SAN ONOFRE NUCLEAR GENERATING STATION, UNIT NO. 2

AMENDMENT TO FACILITY OPERATING LICENSE

Amendment No. 129
License No. NPF-10

AMENDMENT NO. 129 TO FACILITY OPERATING LICENSE NO. NPF-10

FIGURE 3.7-2

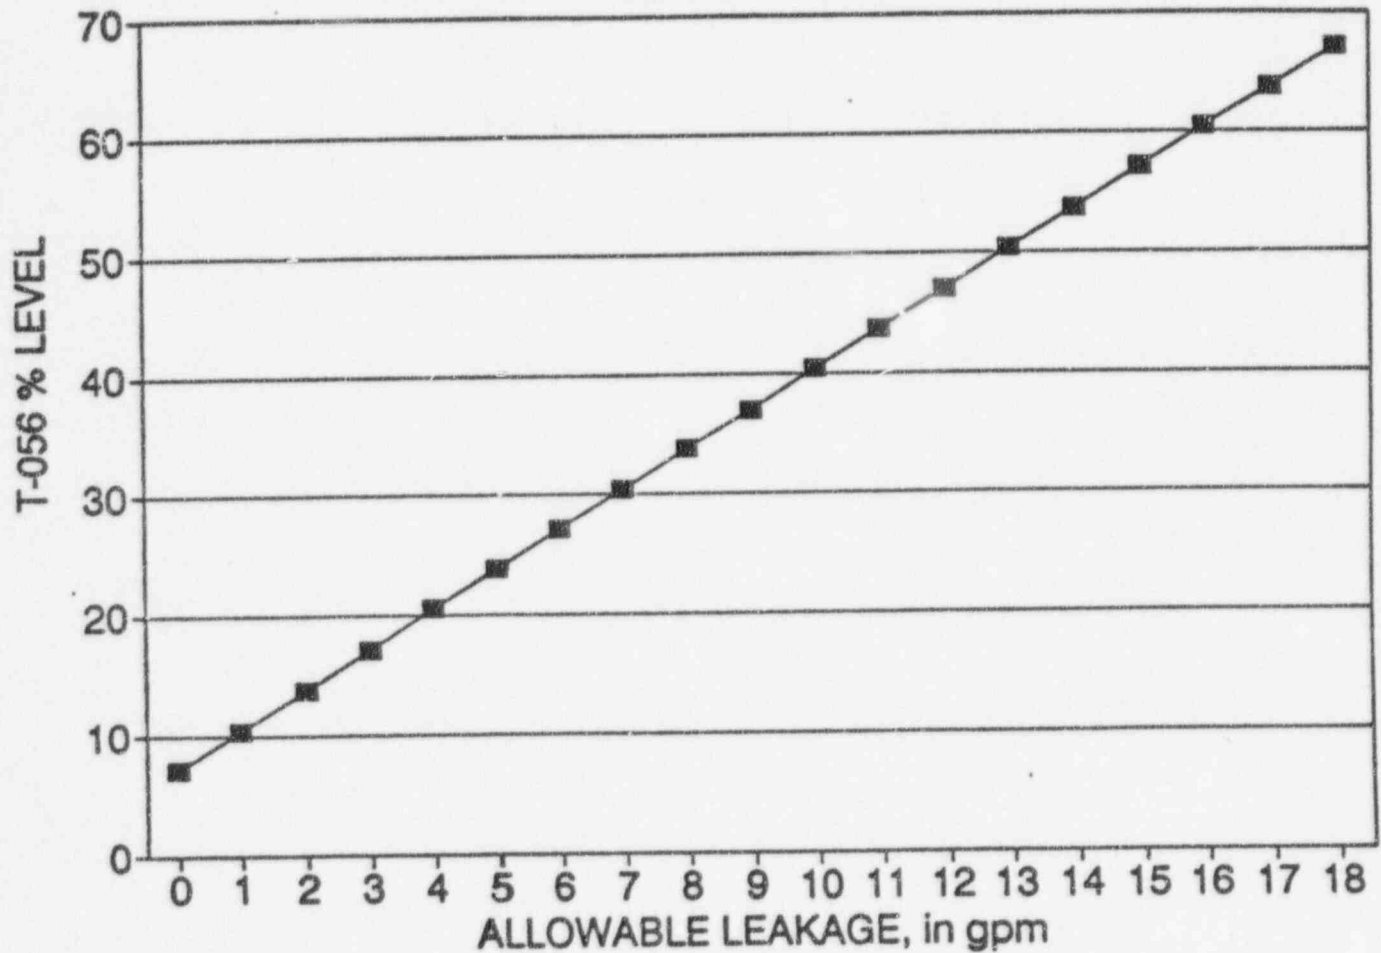
3.7.3.1 Two trains of Component Cooling Water (CCW) Safety Related Makeup System shall be OPERABLE with a contained volume in the Primary Plant Makeup Storage Tank at or above the level specified in Figure 3.7-2.

- a. With one CCW Safety Related Makeup flow path inoperable, restore the flow path to OPERABLE status within 7 days.
- b. With the Primary Plant Makeup Storage Tank level less than that required by Figure 3.7-2, and/or both CCW Safety Related Makeup flow paths inoperable, restore the Primary Plant Makeup Storage Tank level and one CCW Safety Related Makeup flow path to OPERABLE status within 8 hours.
- c. With Actions a or b, above, not completed in the specified action times, be in HOT STANDBY within the next 6 hours, and be in COLD SHUTDOWN within the following 24 hours.
- d. The provisions of Specification 3.0.4 are not applicable.

For any point on the curve in Figure 3.7-2, the required water level is based on the associated leak rate from the CCW system, an unrecoverable volume and a level instrumentation Total Loop Uncertainty (TLU). For example, a leak rate of 18 gpm for seven days corresponds to a volume of 181,440 gallons. If the TLU and the unrecoverable volume are added to this, the total is 203,100 gallons. Dividing this number by the total tank volume of 303,500 gallons yields 67%.

Figure 3.7.7.1-1

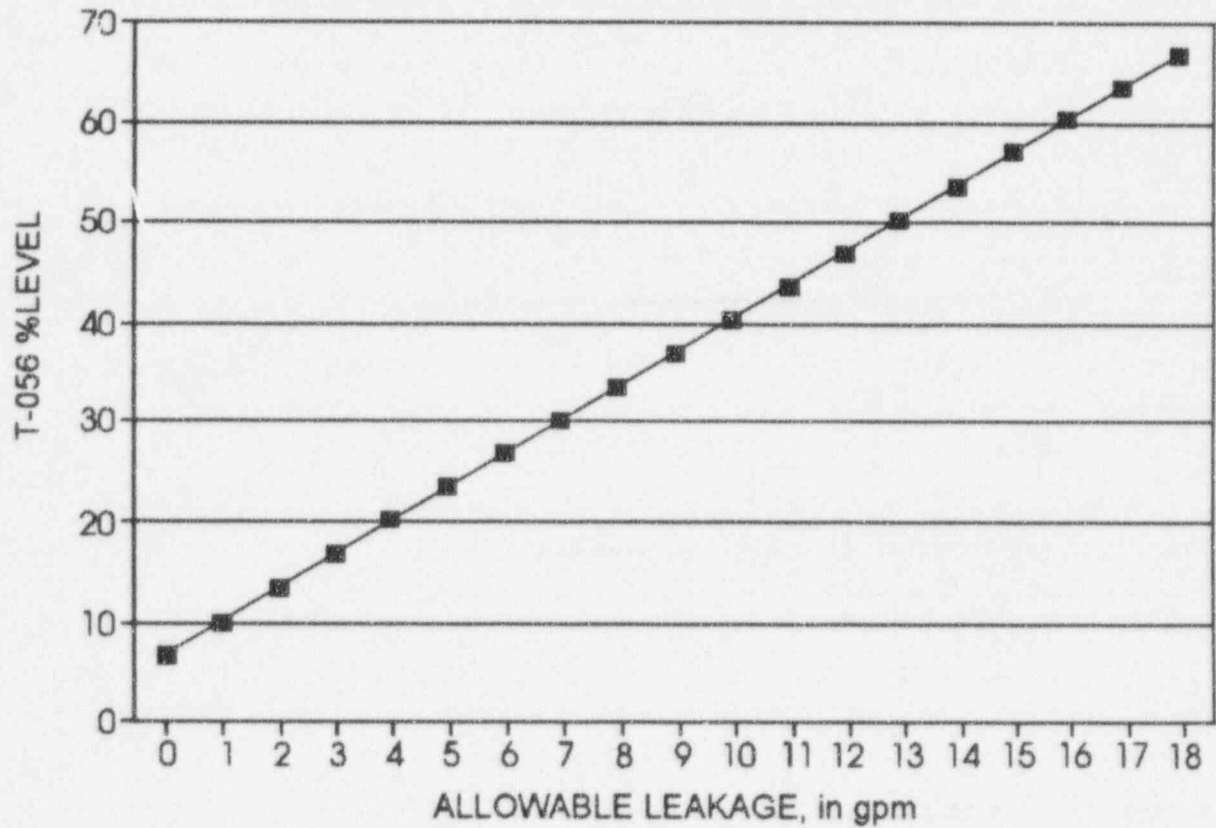
LCO 3.7.7.1 Two trains of Component Cooling Water (CCW) Safety Related Makeup System shall be OPERABLE with a contained volume in the Primary Plant Makeup Storage Tank \geq the level specified in Figure 3.7.7.1-1.

Operating experience shows that the likelihood of Primary Plant Makeup Storage Tank level dropping below 66% (which corresponds to an allowable CCW leakage of 18 gpm based on Figure 3.7.7.1-1) is extremely low. Also, a Probabilistic Risk Assessment (PRA) was performed to assess the increased risk of core damage from an 8 hour allowed outage time for two trains of the CCW Safety Related Makeup System. The PRA indicated that the increased risk of core damage from an 8 hour allowed outage time is less than 1×10^{-6} per year. This increase in core damage risk is considered acceptably small.

This SURVEILLANCE REQUIREMENT measures CCW leakage to ensure the PPMU Tank level is adequate in accordance with Figure 3.7.7.1-1. The specified frequency is considered adequate in view of the special alignment required to perform this test. This measurement can be performed only when one CCW critical loop can be removed from service. Therefore, this measurement needs to be performed during refueling outages.

FIGURE 3.7-2

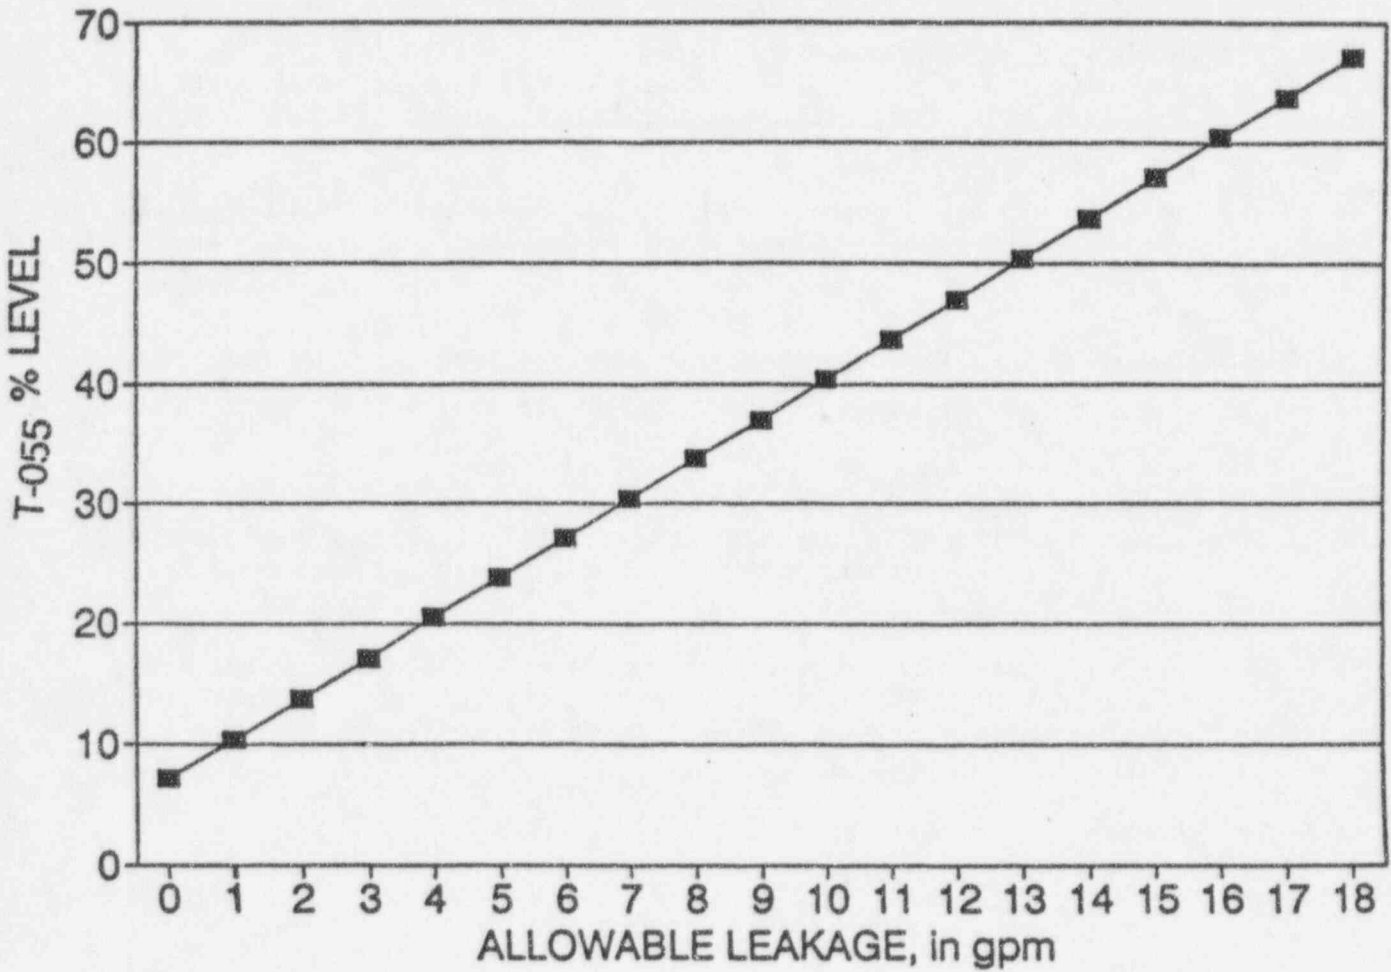
3.7.3.1 Two trains of Component Cooling Water (CCW) Safety Related Makeup System shall be OPERABLE with a contained volume in the Primary Plant Makeup Storage Tank at or above the level specified in Figure 3.7-2.

- a. With one CCW Safety Related Makeup flow path inoperable, restore the flow path to OPERABLE status within 7 days.
- b. With the Primary Plant Makeup Storage Tank level less than that required by Figure 3.7-2, and/or both CCW Safety Related Makeup flow paths inoperable, restore the Primary Plant Makeup Storage Tank level and one CCW Safety Related Makeup flow path to OPERABLE status within 8 hours.
- c. With Actions a or b, above, not completed in the specified action times, be in HOT STANDBY within the next 6 hours, and be in COLD SHUTDOWN within the following 24 hours.
- d. The provisions of Specification 3.0.4 are not applicable.

For any point on the curve in Figure 3.7-2, the required water level is based on the associated leak rate from the CCW system, an unrecoverable volume and a level instrumentation Total Loop Uncertainty (TLU). For example, a leak rate of 18 gpm for seven days corresponds to a volume of 181,440 gallons. If the TLU and the unrecoverable volume are added to this, the total is 203,100 gallons. Dividing this number by the total tank volume of 303,500 gallons yields 67%.

Figure 3.7.7.1-1

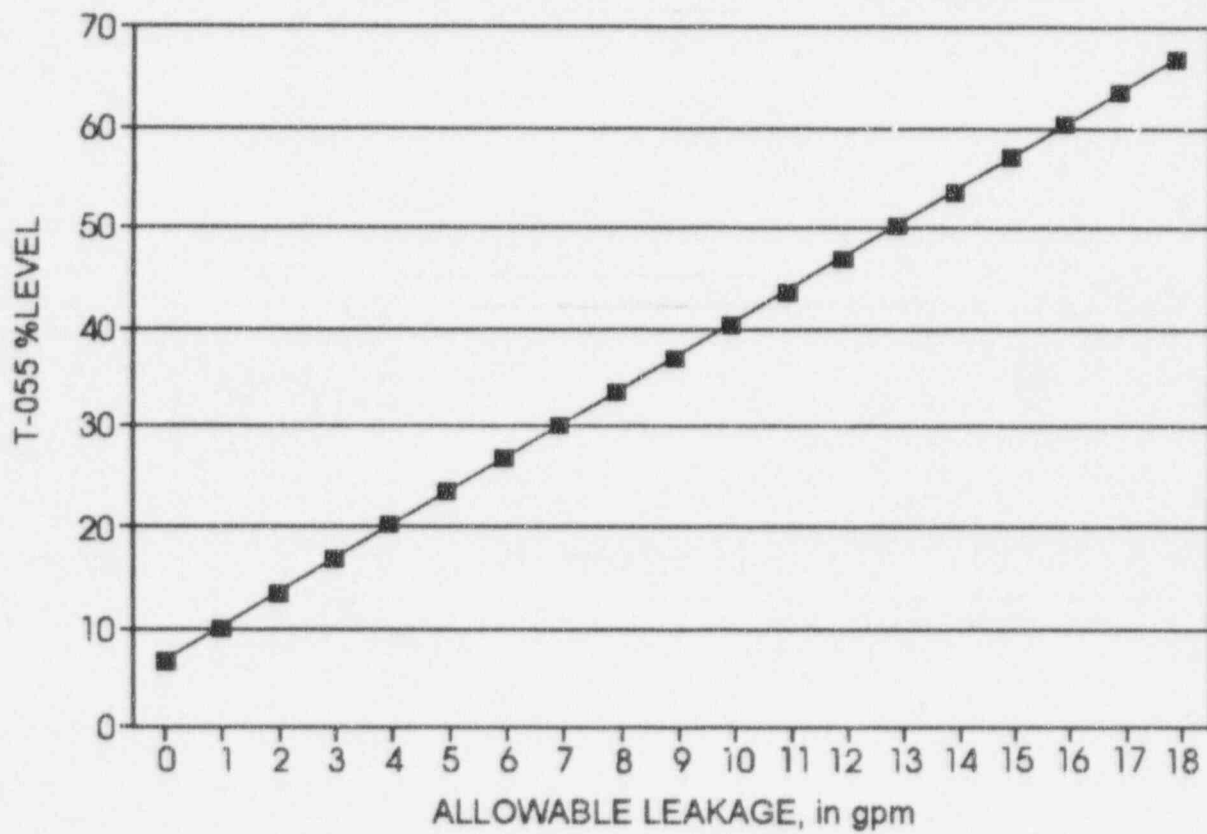
LCO 3.7.7.1 Two trains of Component Cooling Water (CCW) Safety Related Makeup System shall be OPERABLE with a contained volume in the Primary Plant Makeup Storage Tank \geq the level specified in Figure 3.7.7.1-1.

Operating experience shows that the likelihood of Primary Plant Makeup Storage Tank level dropping below 66% (which corresponds to an allowable CCW leakage of 18 gpm based on Figure 3.7.7.1-1) is extremely low. Also, a Probabilistic Risk Assessment (PRA) was performed to assess the increased risk of core damage from an 8 hour allowed outage time for two trains of the CCW Safety Related Makeup System. The PRA indicated that the increased risk of core damage from an 8 hour allowed outage time is less than 1×10^{-6} per year. This increase in core damage risk is considered acceptably small.

This SURVEILLANCE REQUIREMENT measures CCW leakage to ensure the PPMU Tank level is adequate in accordance with Figure 3.7.7.1-1. The specified frequency is considered adequate in view of the special alignment required to perform this test. This measurement can be performed only when one CCW critical loop can be removed from service. Therefore, this measurement needs to be performed during refueling outages.
